TOWN OF CARMEL
ENVIRONMENTAL CONSERVATION BOARD

ENVIRONMENTAL CONSERVATION BOARD AGENDA

RESPONSE TO COMMENTS Town of Carmel ECB
SMP SSTS, Mike Panny
10 Lower Lake Road, Carmel (T), TM # 43.17-1-47

Re: **Response to comments Town of Carmel ECB July 2020 Meeting**
Fatmir Osmanaj
15 Adam Wagner Lane, Carmel (T), Mahopac

OWNER:	SMP HOMES 10 LOWER LAKE ROAD CARMEL (T)	SCALE:	1" = 20'	LATEST REVISION:	
		DATED:	MAY 16, 2019	SHEET No.	S-1
		TAX MAP No.	43.17-1-47

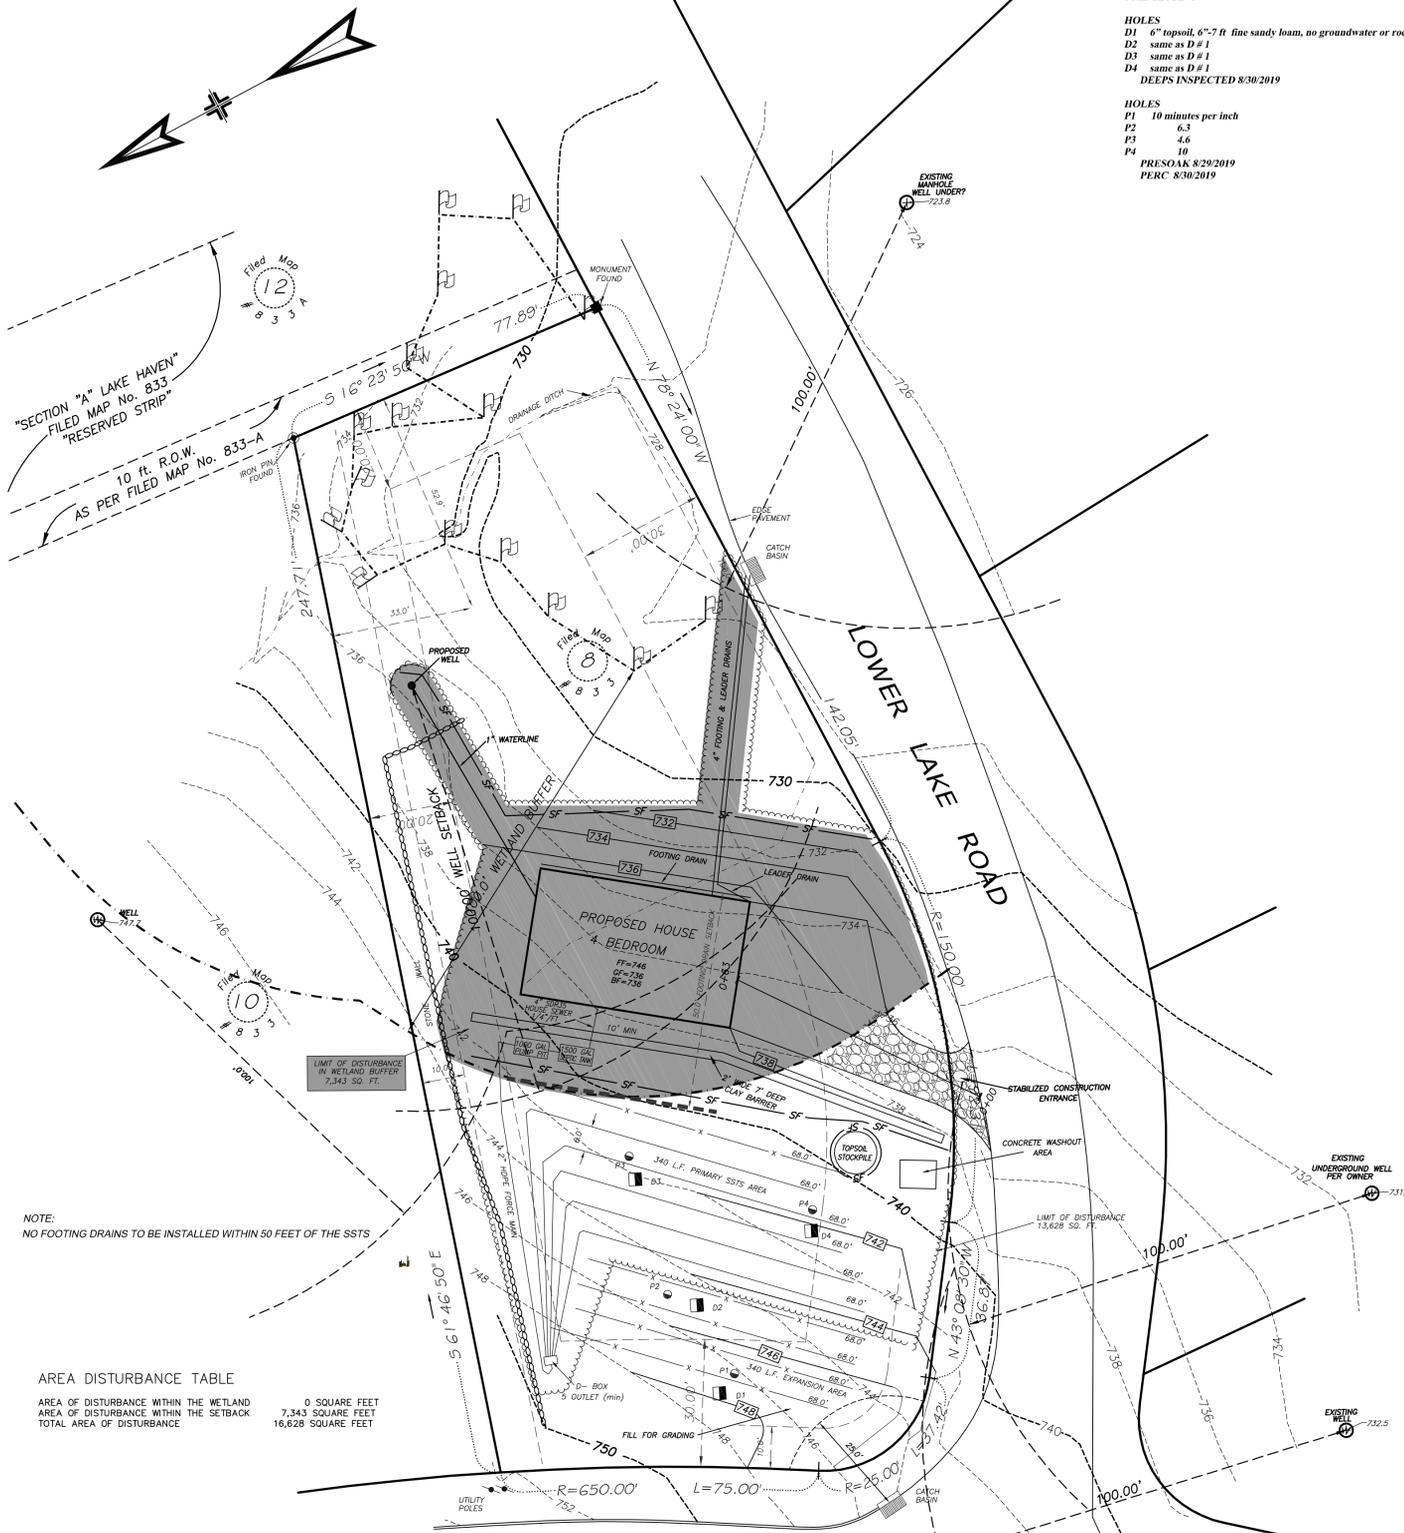
1. Mitigation plans are presented as notes on the plans. Mitigation includes plantings and relocation of the proposed well farther from the wetlands.
2. Notes have been provided on the plans regarding the spill kit, equipment fueling and concrete washout area.

- Silt fence shall be provided with wire backing.
- Construction equipment shall not be fueled on-site.
- A Brute 32 gallon spill kit K-32-0 shall be provided on site to consist of the following:
 - 50 pads, heavy weight
 - 8 socks, 17" x 48"
 - 2 bags siltarator, granular 5# ea
 - 4 temporary disposal bags, 4 mil
 - 4 plastic slip tie, 12"
 - 2 pair nitrile gloves
 - 2 pair safety goggles
 - 1 instruction sheet

- Remove all invasive plants within the site, including Japanese barberry, multiflora rose, wild grape vine, bittersweet vine and phragmites.
- Upon removal of the phragmites is culled out, replant the area with 2 1/2 inch caliper, 8 & 8 and 2 serviceberry (25 gallon container)

LATEST REVISION: SHEET No. S-1

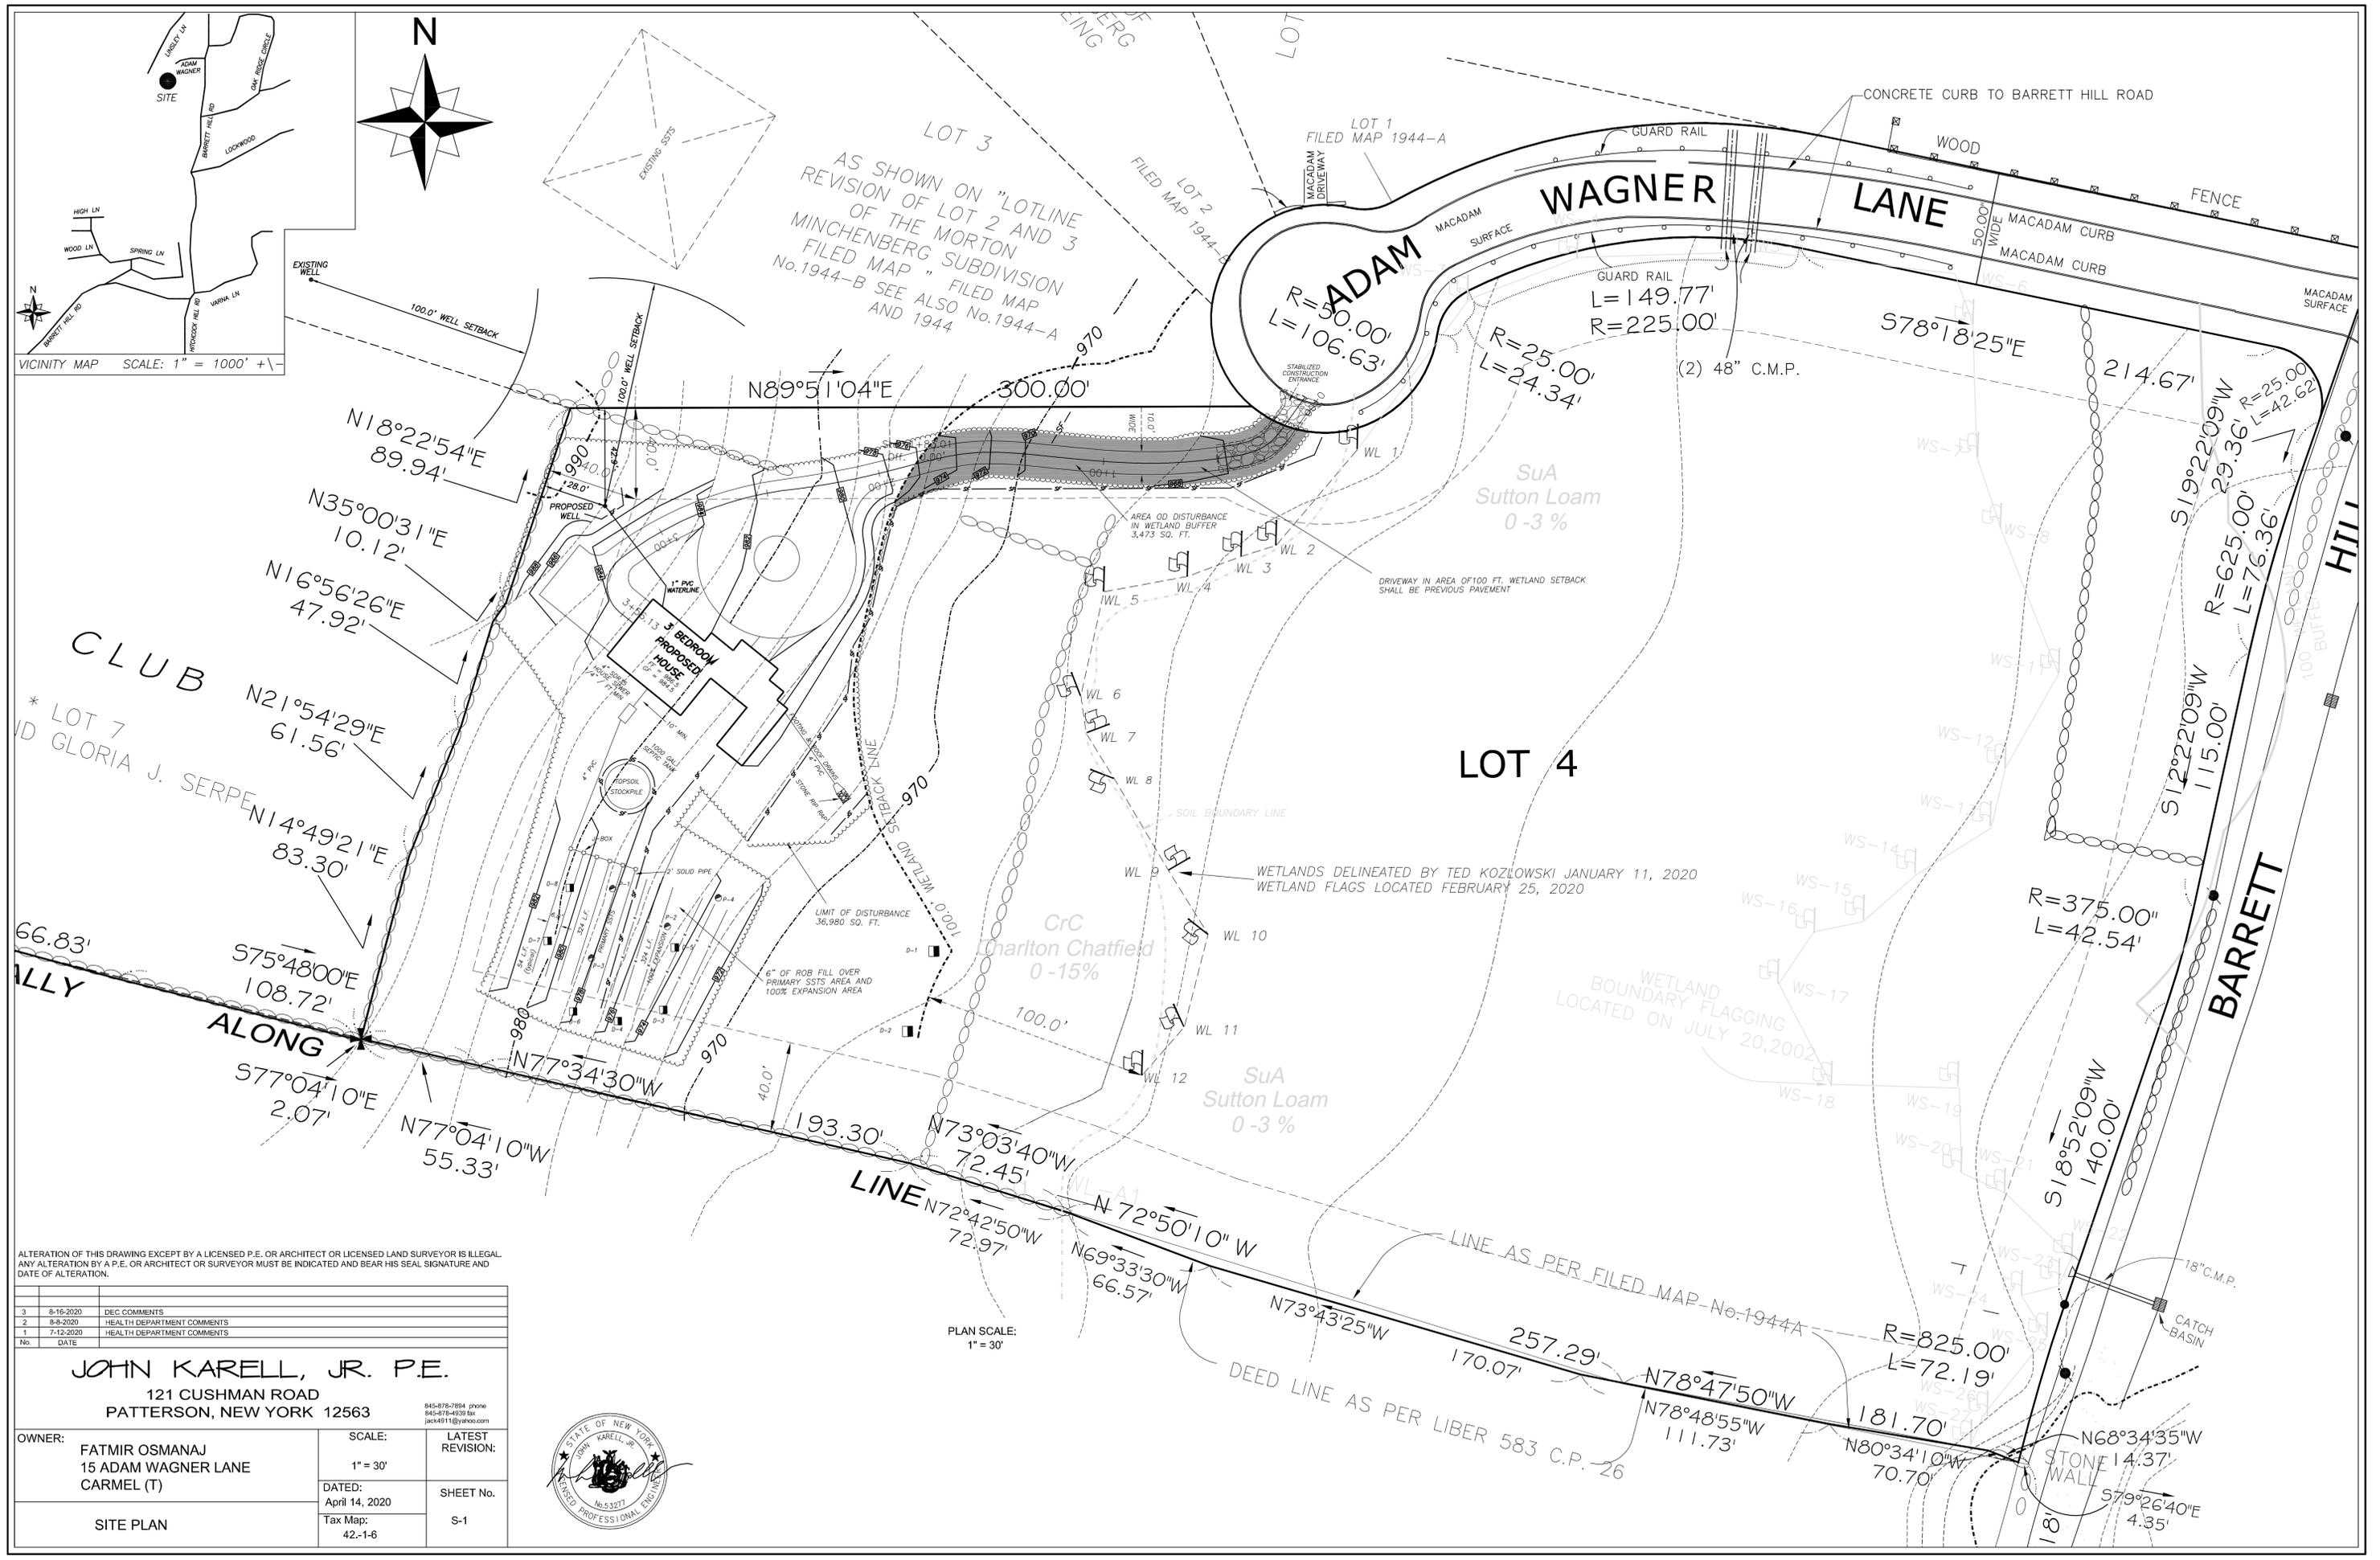
The Joint Application Form states that there are no alternatives to the proposed project. Please provide an alternatives analysis considering the use of gravel or pervious pavement for the driveway within the adjacent area and these options cannot be achieved.

The plans do not show the width of the driveway through the regulated area. The driveway should be the minimum width necessary. Please provide the town or emergency access road width requirements.

1. An application for a DEC wetlands permit was submitted to the DEC. Attached comments were received. A revised submission was submitted to the DEC along with a response memo, copy attached.
2. Pursuant to the DEC comments, mitigation is provided consisting of permeable pavement on the driveway within the 100 foot wetland buffer.
3. Pursuant to DEC comments the driveway width has been reduced to 10 feet.

1. Pervious pavement is shown for that portion of the driveway that is within the 100 foot setback of the State Wetland.
2. The width of the driveway was shown as 12 feet. This is the normal driveway width at this time. The Towns minimum driveway width is 10 feet. The driveway width has been reduced to 10 feet.
3. The construction sequence has been placed on the plan. The sequence is also in the SWPPP document, copy attached.
4. A note has been placed on the plans that all tree removal for this project will occur between November 1 to March 31, to avoid potential impacts to the bat species. This would be stipulated as a condition of any permit issued for this property.
